From: [Barna, Roberta \(EXT\)](#)
To: [Rosie Dinnen](#)
Cc: [Planning \(SMDC\)](#)
Subject: SMD/2022/0267 - Blythe Park (Phases 4 and 5) - LLFA Response
Date: 22 October 2024 15:21:00
Attachments: [image001.png](#)
[image002.png](#)
[image003.png](#)

Good Afternoon Rosie,
Further to the latest information received regarding SMD/2022/0267– Blythe Park Phases 4 and 5. I note that the application only provides information relating to Phase 4 of the development and wonder instead if these comments would be more relevant to SMD/2022/0268 instead?

Staffordshire County Council Flood Risk Management Position

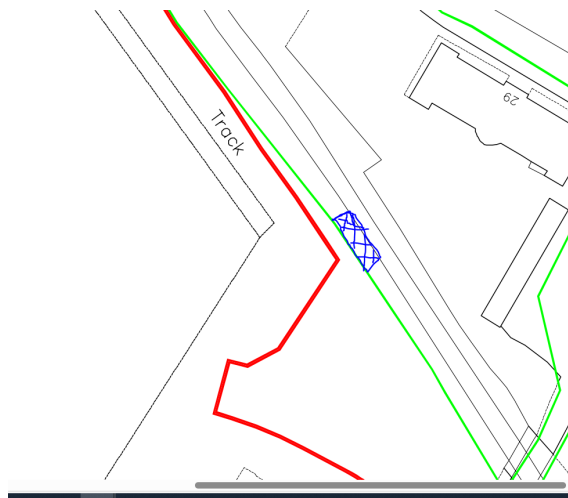
- With regard to the outfalling swale being constructed outside of the red line boundary, the blue area on the screenshot is not within your ownership (as demonstrated on the submitted Location Plan Rev D) please confirm who owns this area and if you have their permission to construct a swale here and access it for long term maintenance.

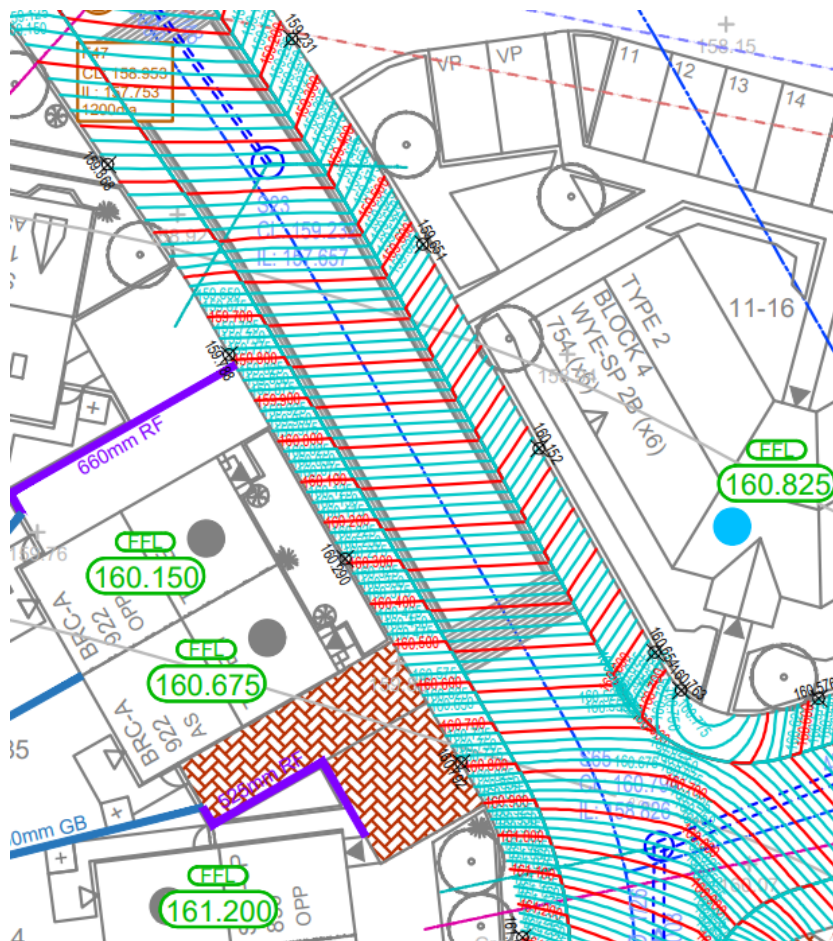
Can you resupply the flood path plan

BMK23278_RPS_xx_xx_DR_C_111-01 in line with the updates made to the drainage plan to allow us to make an assessment of exceedance flows on site:

- Can you confirm compliance with the FRA: Across the proposed development site a differential of at least 0.3m will be created between road elevation and the finished floor level within adjacent units. This will ensure that any flood water derived from localised sources such as existing or proposed drainage infrastructure or overland flows from higher land to the south will not preferentially flow into buildings but will instead be conveyed through the development down to the River Blithe.
- Can you also confirm that FFLs are to be set at least 150mm above surrounding ground level to mitigate against the residual impacts of exceedance on a plan with levels.
